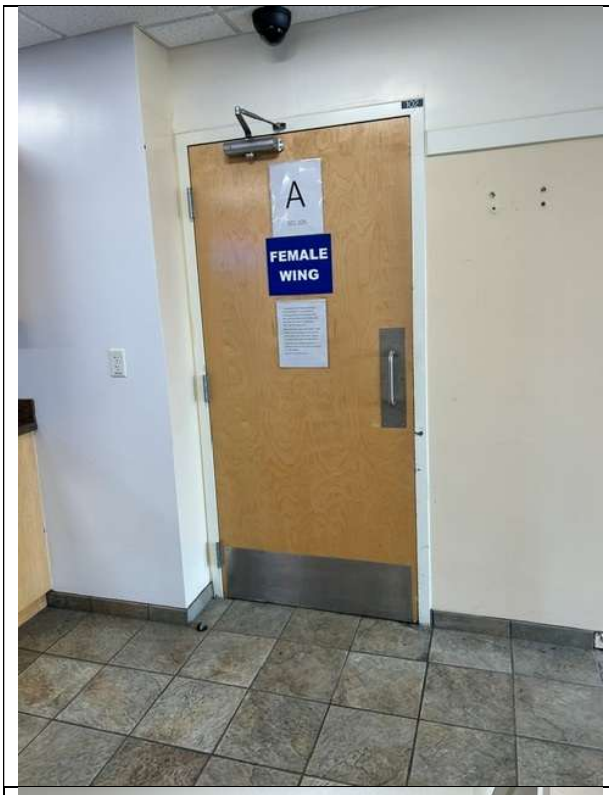
15. Is the contractor responsible for providing the doors? If so, are the required doors paint-grade or finish-grade?

Wing Door: note handle, kick plate, closer
	Office doors: note kick plate and handle and locking mechanism.

Answer: Yes, contractor is responsible for providing doors. Doors shall be finished to match existing as close as possible and shall be outfitted with hardware to match existing (kickplates, windows, peeps, hardware, closures etc) Pictures are attached below for reference for those who did not attend site visit.

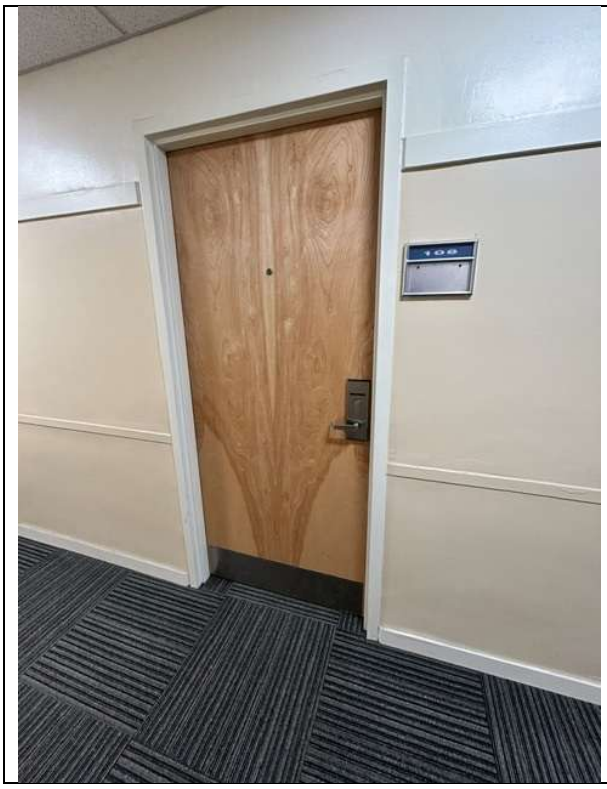
Room door: note peep, kick plate, handle and locking mechanism. Interest to add door closures was noted on RFI responses.

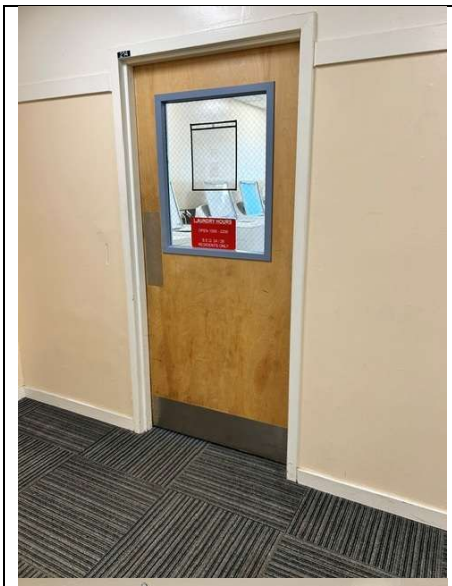
Laundry room door: Note kickplate, handle, window.
